MFN 06-364 Supplement 3

**Subject: Response to Portion of NRC Request for Additional
Information Letter No. 33 - Containment Systems - RAI
Numbers 6.2-59 S01, 6.2-60 S01, and 6.2-62 S02**

Related to ESBWR Design Certification Application

RAI Numbers 6.2-59 S01, 6.2-60 S01, and 6.2-62 S02

Figure 6F1-1 MSLB - Effect of Break Areas on Transient DW Pressures

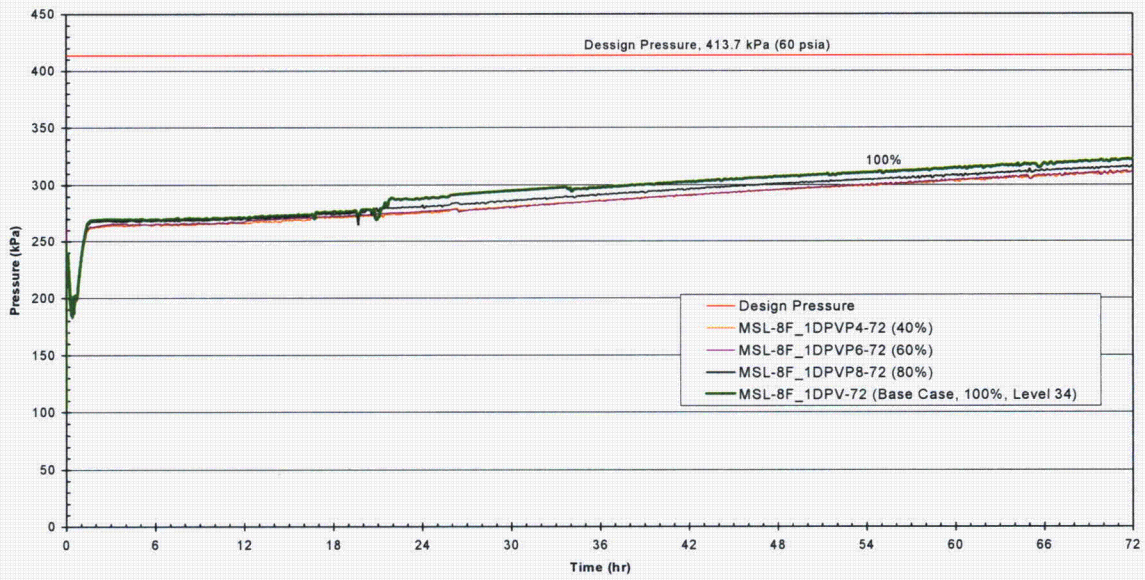
In response to RAI 6.2-60, GENE updated DCD, Tier 2, Revision 3, Section 6.2.1.3 to state that "[c]ontainment design basis calculations are performed for a spectrum of possible pipe break sizes and locations to assure that the worst case has been identified." In response to part (B) of RAI 6.2-60, GENE stated the TRACG results regarding break sizes will be incorporated into the DCD.

- A. Explain whether you considered different locations of breaks in addition to the difference elevations of breaks as discussed in response to part (c) of RAI 6.2-60.*
- B. Incorporate the response to part (c) of RAI 6.2-60 into the DCD.*

Parametric cases were performed with the break area varied (for both ends of the break pipe) from 100% break area to 40%, 60%, and 80%, respectively. The peak drywell (DW) pressures for these cases are summarized in Table 6F1-1. The transient DW pressures of these cases are compared and shown in Figure 6F1-1.

The peak DW pressures for these cases occur near the end of the calculation (72 hours), and the case with larger break area calculates slightly higher peak DW pressure. The base case (100% break area) calculates a peak DW pressure of 323 kPa. It should be noted that the corresponding margin to the design pressure of 413.7 kPa (60 psia) is 29%.
